LRD Planning Application to Fingal County Council

Response to LRD Opinion

St. Mochta's LRD

Proposed Large-Scale Residential Development

Figure 3: Density in Context - Extract from Design Statement prepared by O'Mahony Pike Architecture

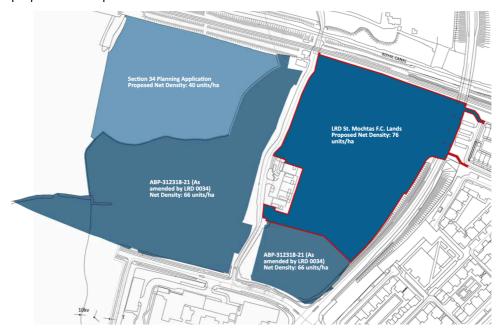
• The proposed density of 74 units per hectare (uph) is acceptable considering the location and accessibility of the site; density range (up to 150 dph) per the Compact Settlements Guidelines for Planning Authorities (2024) (accessible suburban/urban extension location). The proposed density is also acceptable regarding the density range (50-75 uph) per the Kellystwon LAP.

We note the Council's acceptance of the proposed density of 76 units per hectare, which is within the acceptable range set out in both the Kellystown LAP and the Compact Settlements Guidelines (2024), and we refer to the O' Mahony Pike Design Statement for further detail.
